Remarks

This paper is submitted in response to the Office Action mailed October 6, 2004. Reconsideration of the application is requested in view of the foregoing amendments and the following remarks.

Amendments to the Drawings

RED - LINE

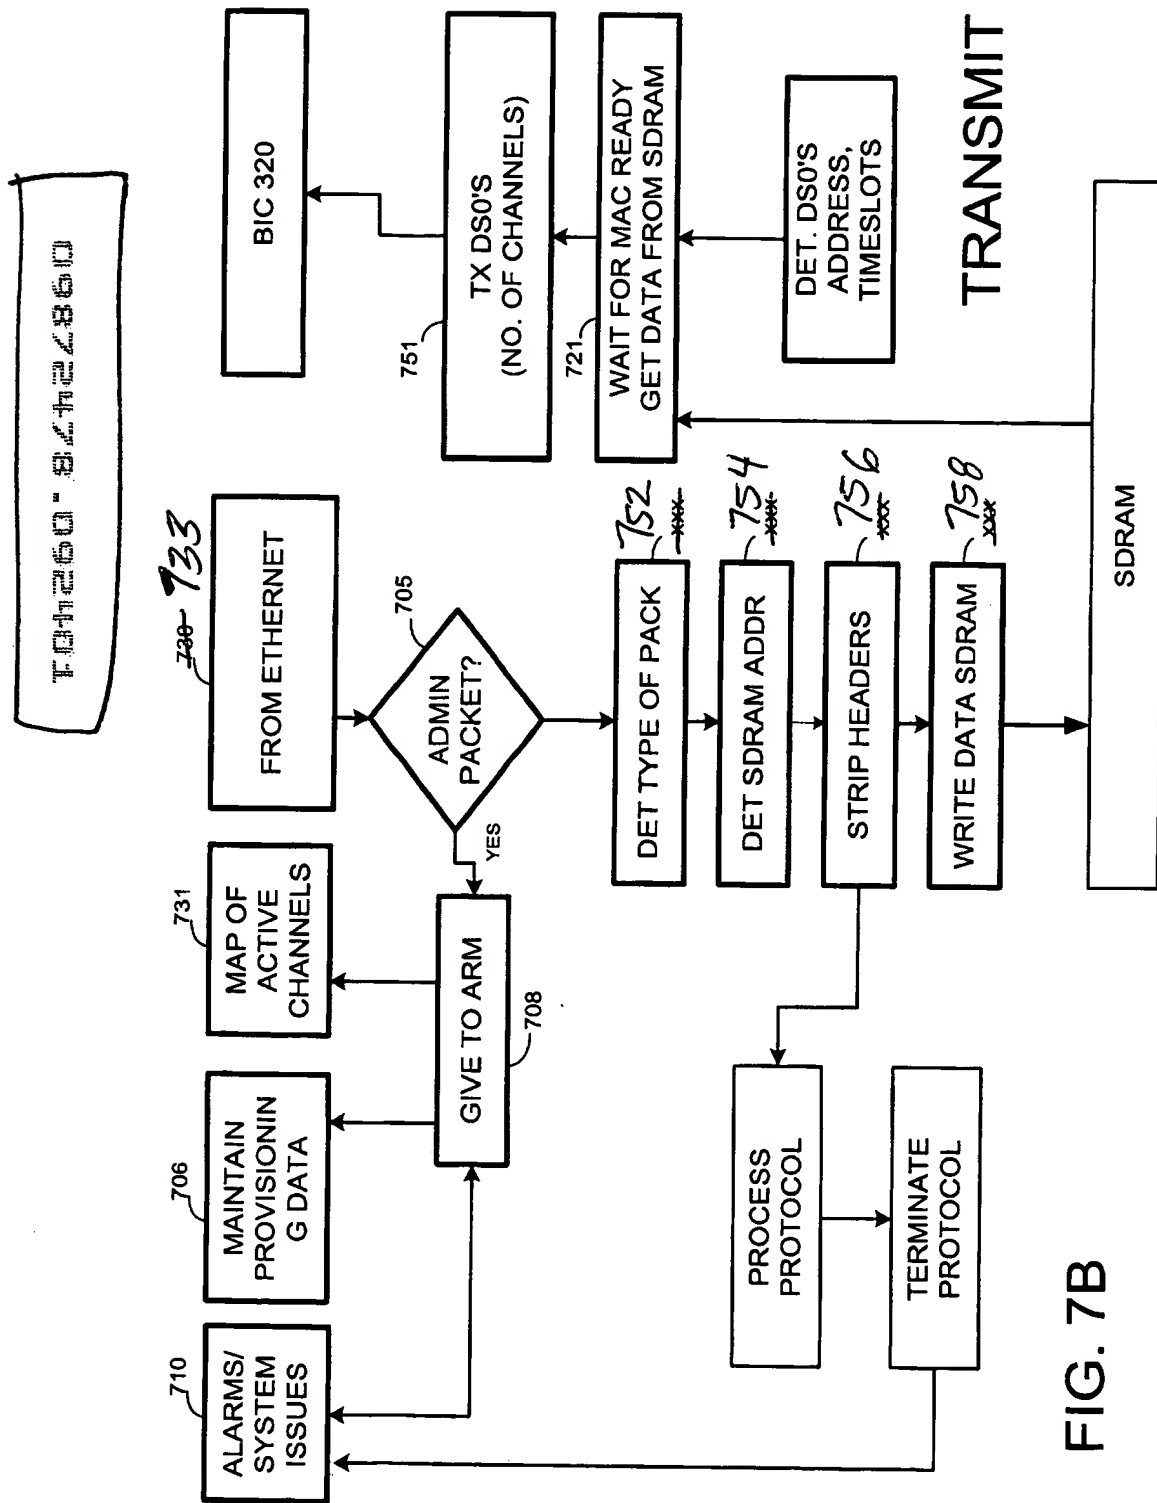
Figures 1 and 2 are amended by submission of Replacement Sheets to correct the informalities noted by the Examiner; namely, to add reference numbers that appear in the specification but were omitted in the drawings. Additionally, figure 7B is amended to add reference numbers to elements not previously numbered, and to change reference "730" to "733" as 730 was already used in figure 7A. A red-line copy of figure 7B is enclosed showing the changes. Acceptance of the revised drawings is requested.

Informalities in the specification observed by the Examiner are corrected by the amendments to the specification above; see corrections 1-3 above. In addition, item 4 is to correct a misspelling, and item 5 corrects a reference number for consistency with the drawing. Item 6 adds narrative description corresponding to the items now numbered in corrected figure

7B. No new matter is added as the narrative merely reflects the content of the drawing figure 7B as filed.

1. Amend drawing figures 1, 2 and 7B by substituting the appended Replacement Sheets.
